February 26, 2007

DOCKET NO.: 40-0235

SUBJECT: SUMMARY OF NRC'S REVIEW OF AAR MANUFACTURING,  
INC'S UPDATED DOSE ASSESSMENT TO DEMONSTRATE  
COMPLIANCE WITH THE LICENSE TERMINATION RULE FOR  
RESTRICTED RELEASE OF THE WESTERN PARCEL AND  
UNRESTRICTED RELEASE OF THE EASTERN PARCEL

**Figure 1 Probabilistic Dose Assessment Results—Eastern Residential**

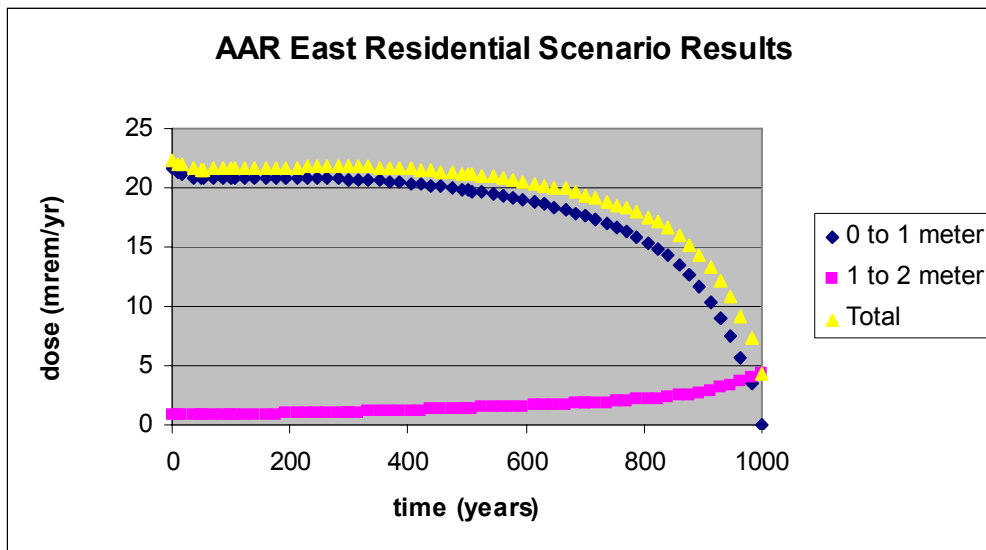
Table 1 presents the results of NRC's independent dose assessment assuming source concentrations consistent with removal of soil in four 100 m<sup>2</sup> grids in the western parcel and two grids in the eastern parcel. Figures 1 through 3 graphically present these results. These results indicate that AAR can meet the dose criterion of 0.25 mSv/yr (25 mrem/yr) to the average member of the critical group for unrestricted release of the eastern parcel and restricted release of the western parcel (with assumed institutional controls); and 1 mSv/yr (100 mrem/yr) to the average member of the critical group for restricted release of the western parcel (with assumed failure of institutional controls). Other criteria specified in 10 CFR Part 20, Subpart E, may need to be considered prior to release of the site (e.g., ALARA and financial assurance). For additional details, please see the enclosed report.

Scenario	Area	Contaminant	Dose	Revised Source Concentration (pCi/g)
Residential (gardener)	Eastern (unrestricted use)	Total Thorium	22.4 mrem/yr @ time=0 years See Figure 1	8.0 (0-1 meter) 1.2 (1-2 meter)
	Western (loss of institutional controls)	Total Thorium	94 mrem/yr @ time=0 years See Figure 2	40 (0-1 meter) 12 (1-2 meter)
Industrial	Western (with institutional controls)	Total Thorium	23.8 mrem/yr @ time~700 years See Figure 3	40 (0-1 meter) 12 (1-2 meter)
